ADDENDUM NUMBER ONE

Indiana University
Launch Accelerator for Biosciences
1302 Indiana Ave.
Indianapolis, IN 46202

Addendum Dated: OCT 16, 2025

IU Project #: 20250072
BSALS Project #: 00360481

LA100

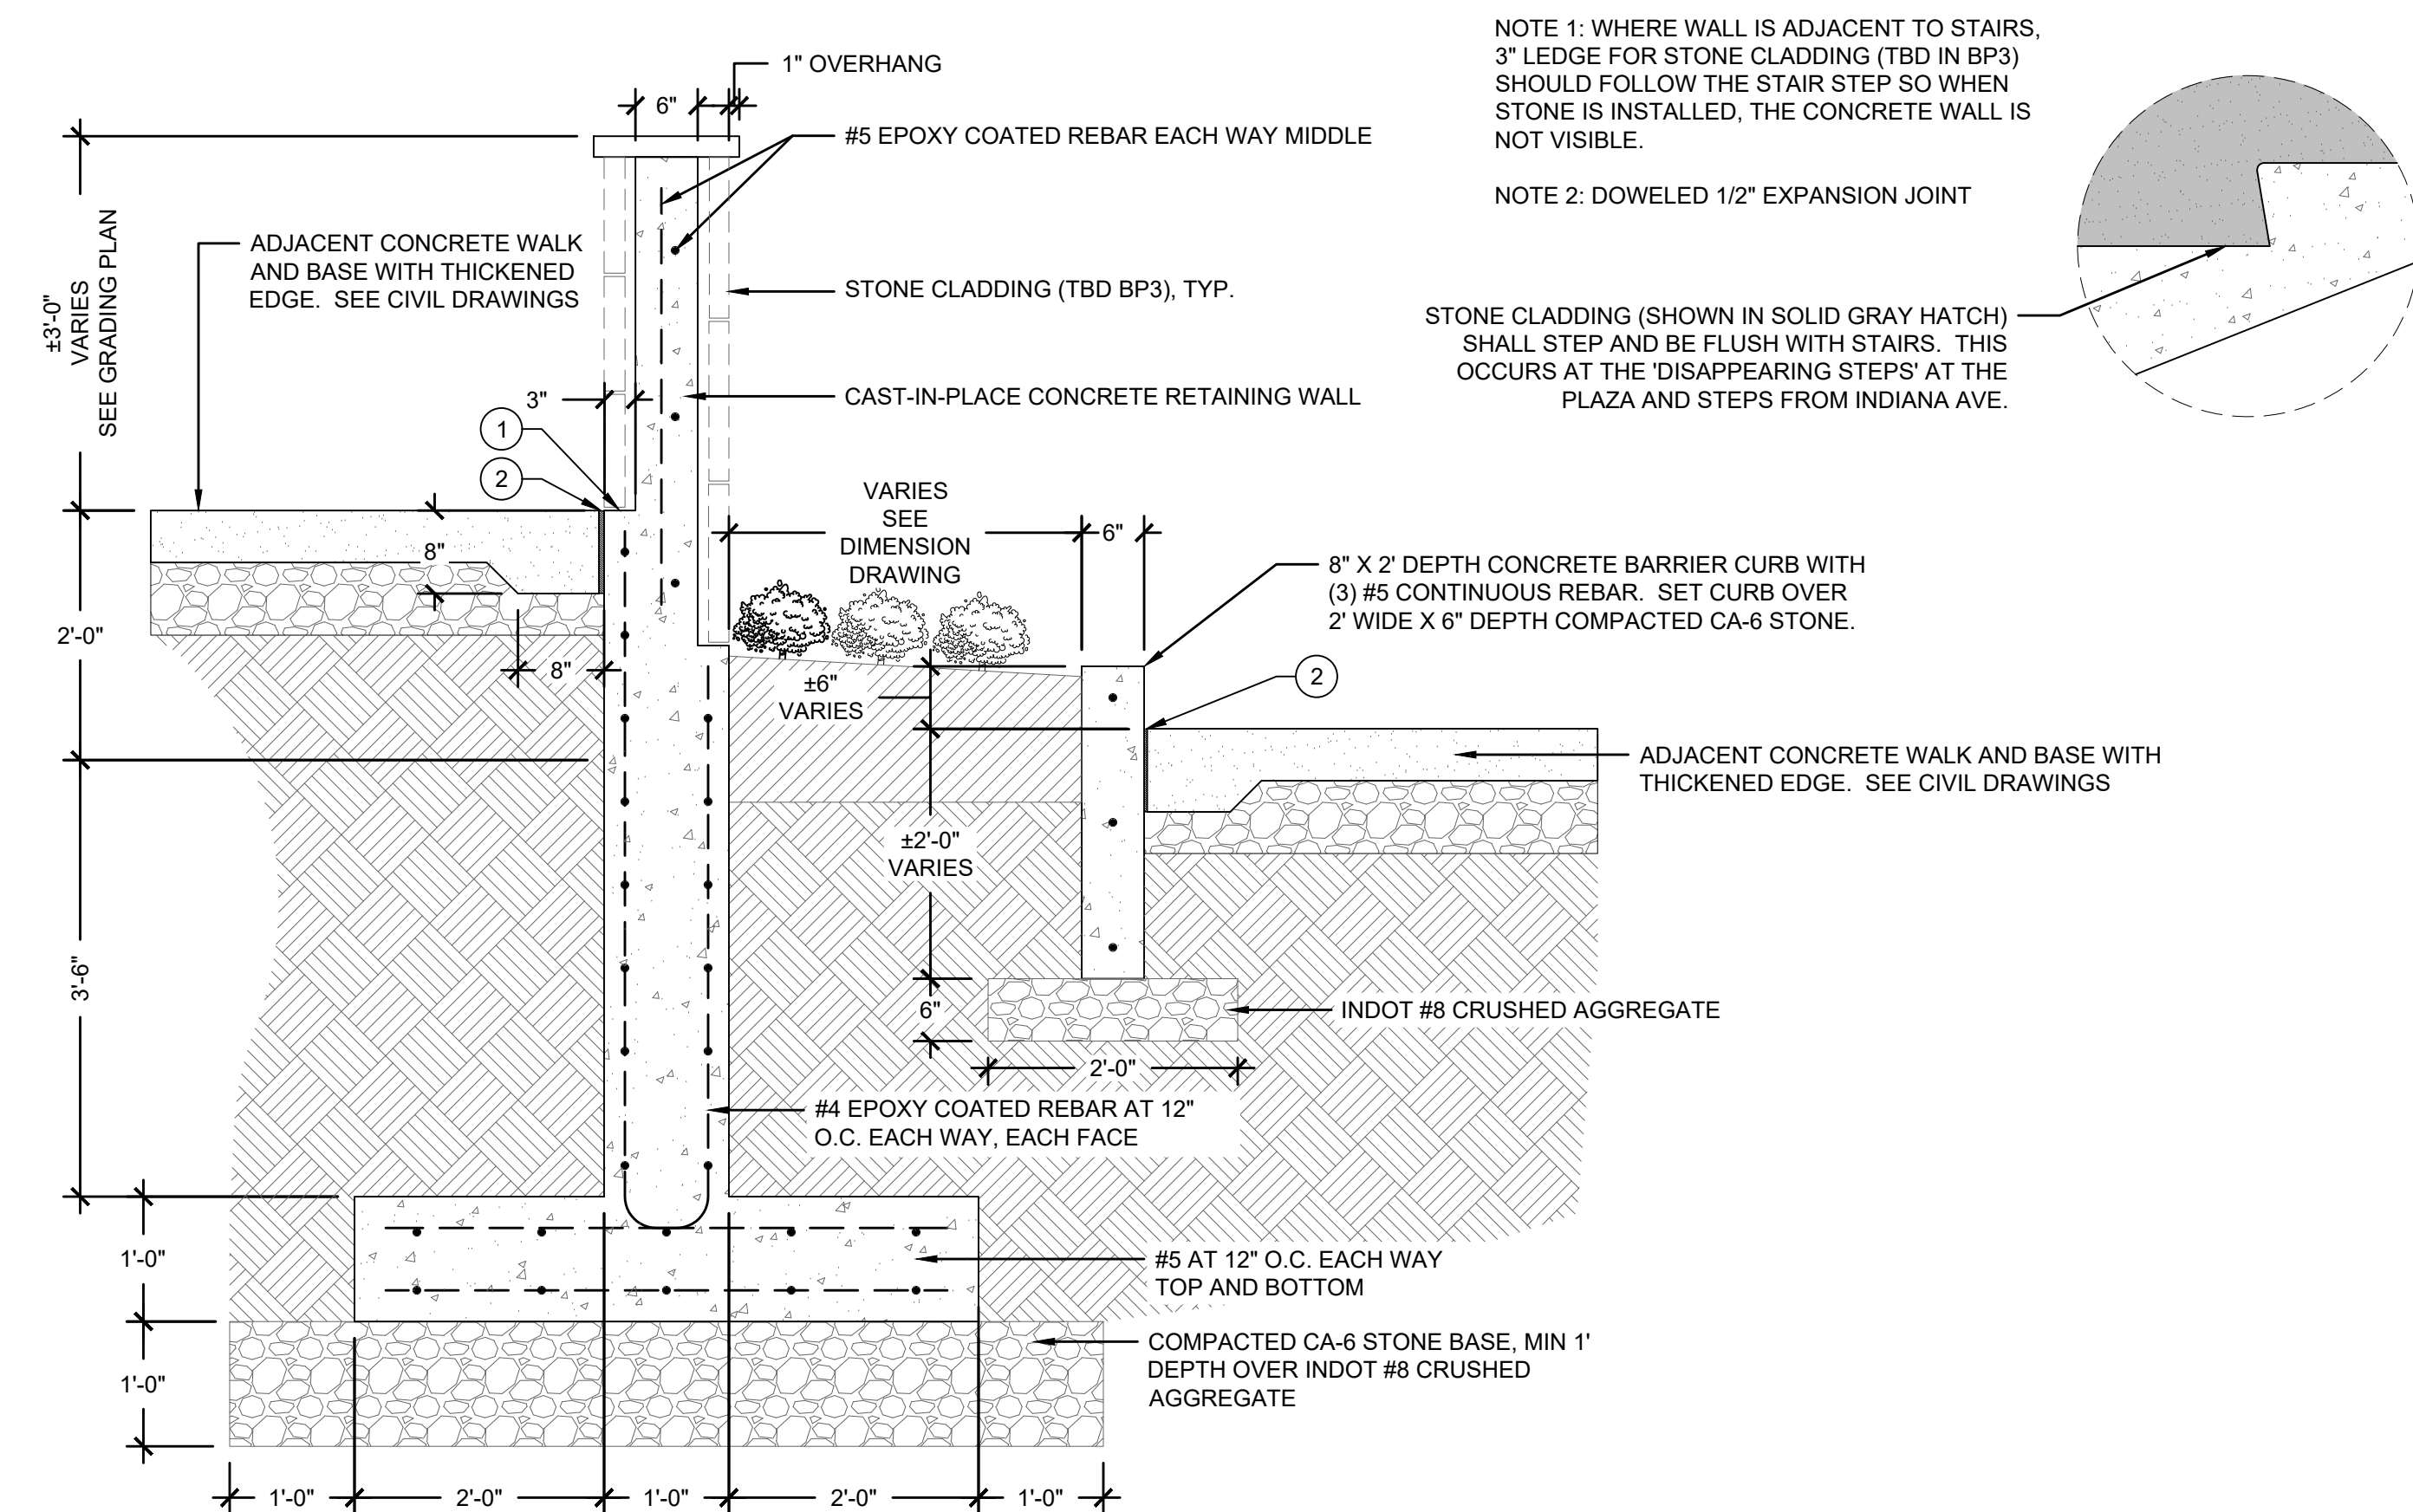
8. **Sheet LA100:**
 - a. Revised quantity of ornamental trees in Plant Schedule and Landscape Plan.
9. **Sheet LA201:**
 - a. Revised Trash Receptacle Detail based on new product selection.

1 FOUNDATION PLAN - AREA A

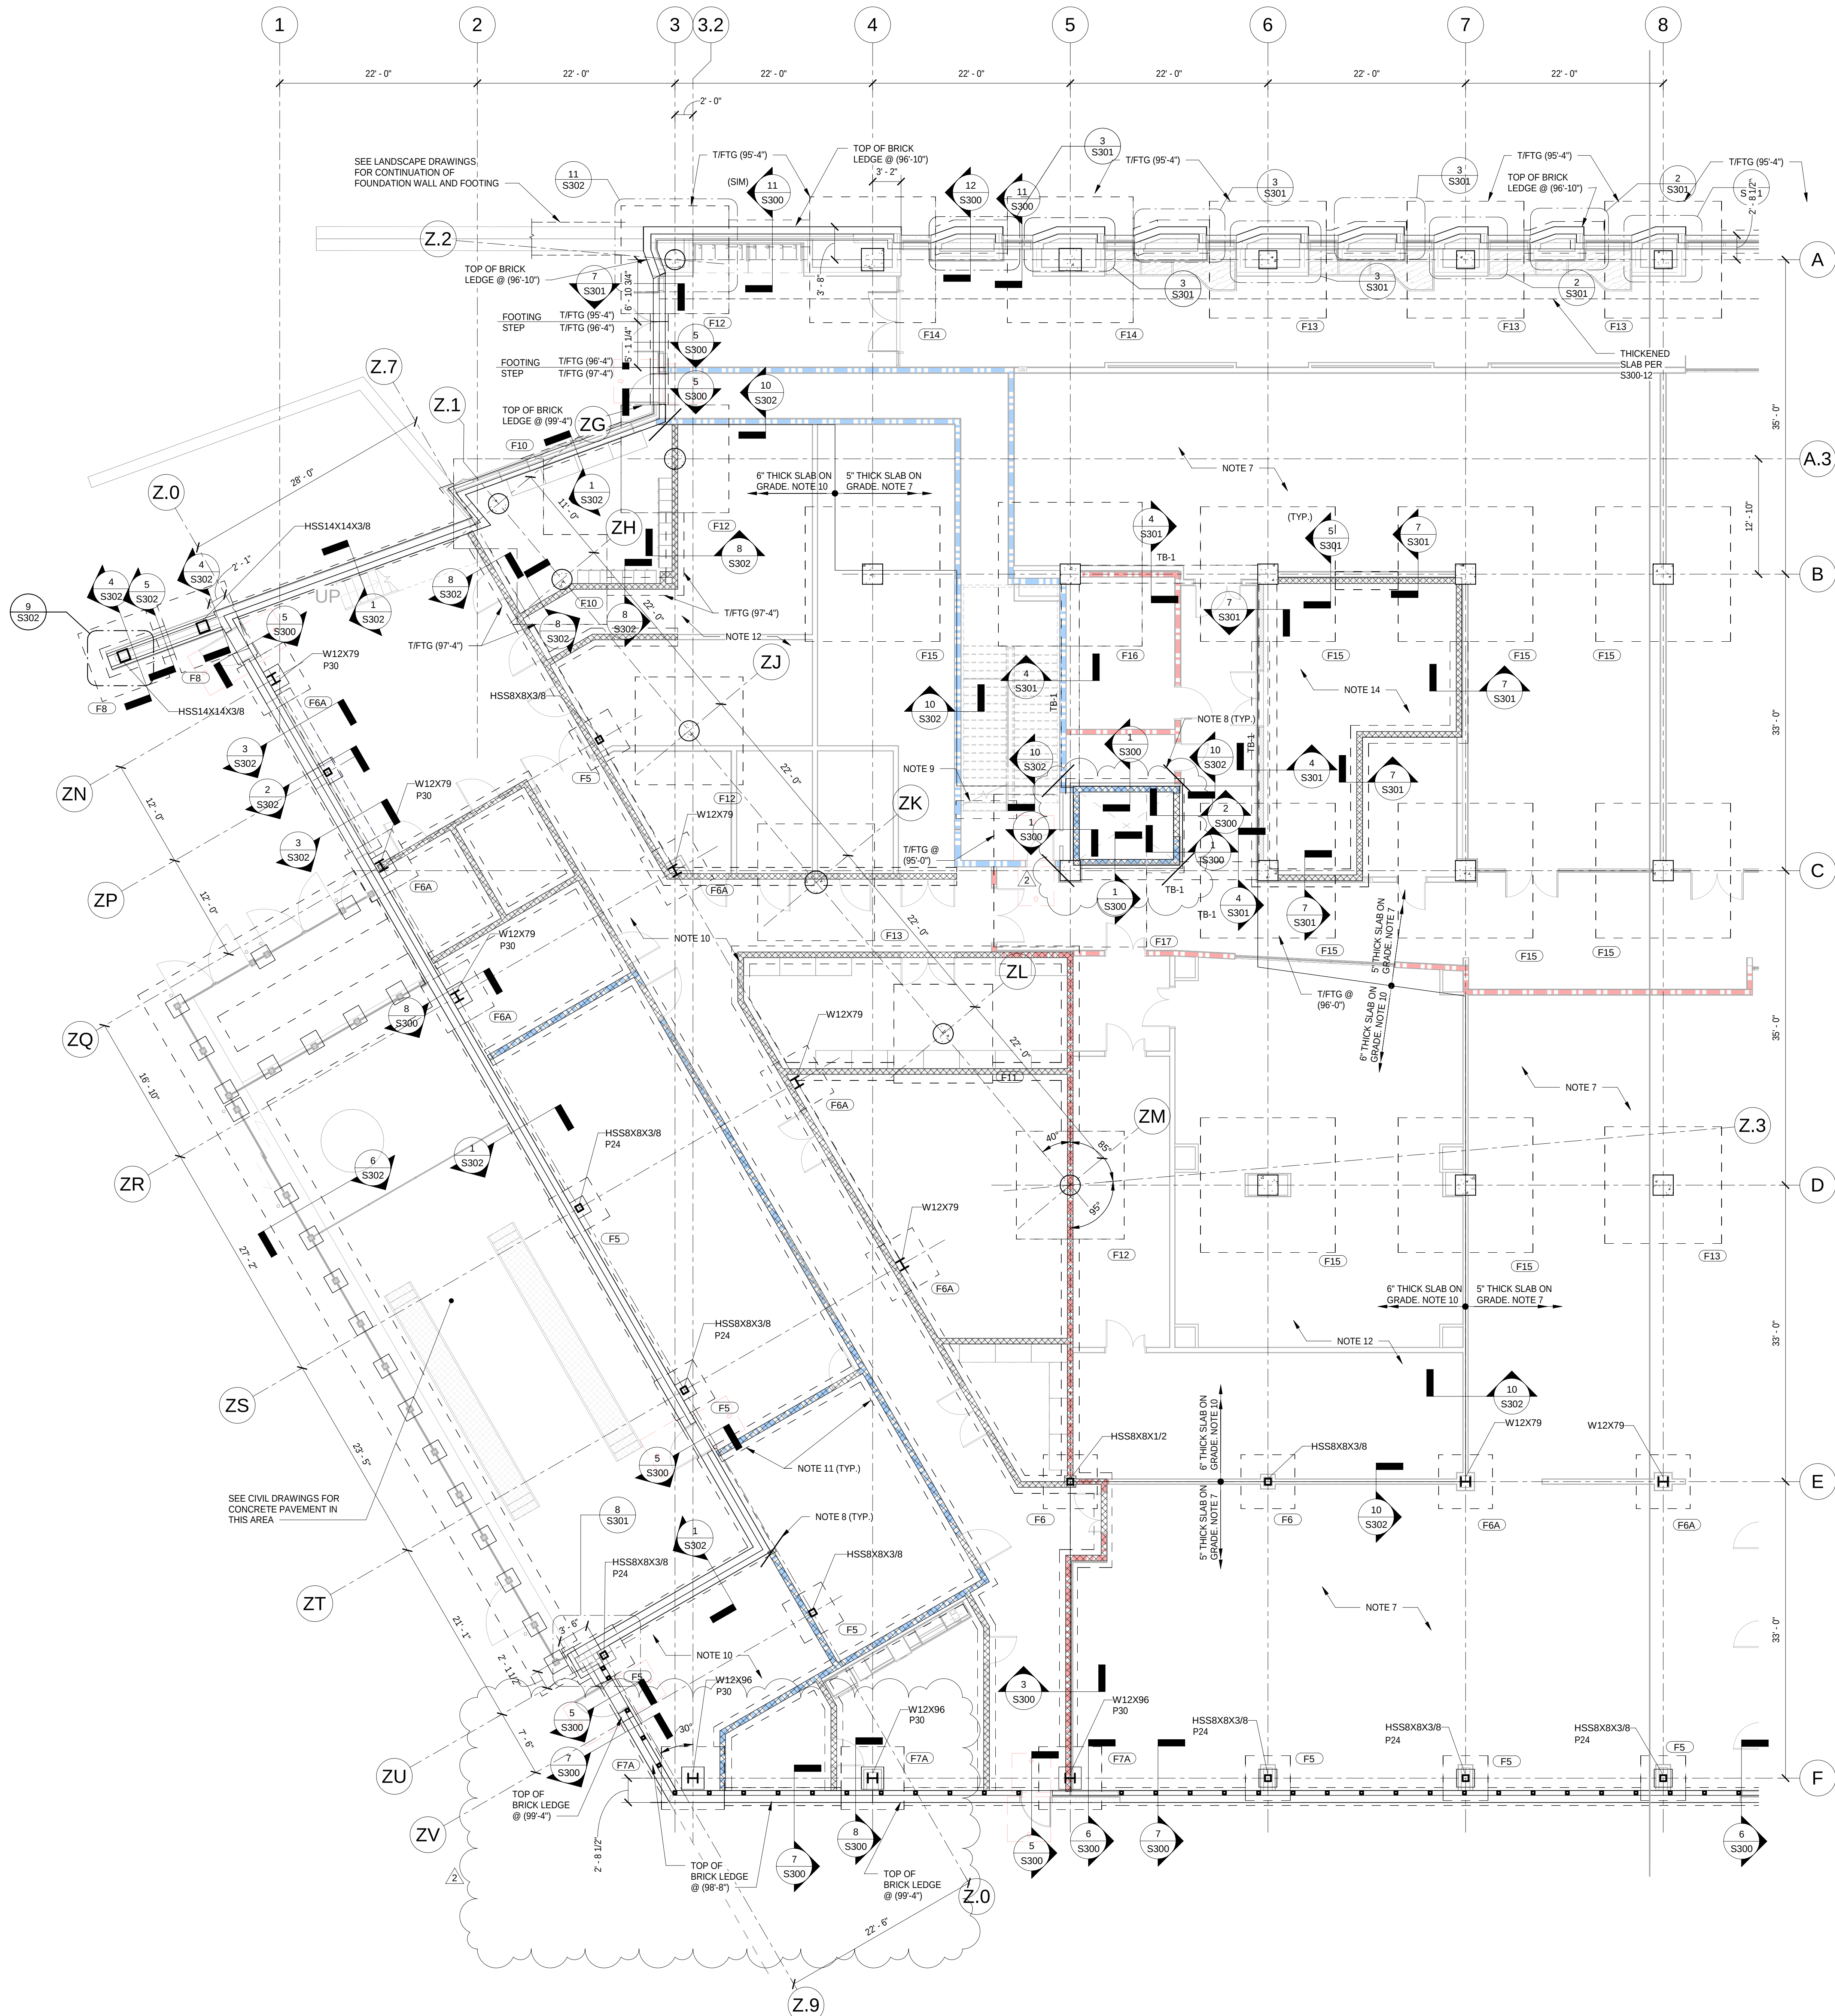
- b. Revised Bike Rack Detail based on new product selection.
10. **Sheet S110A:**
 - a. Add brick ledge step at column line ZV along Z.9 as shown on the clouded portion of the attached revision drawing.

- b. Add brick ledge step at column line 4 along F as shown on the clouded portion of the attached revision drawing.
11. **Sheet S110B:**
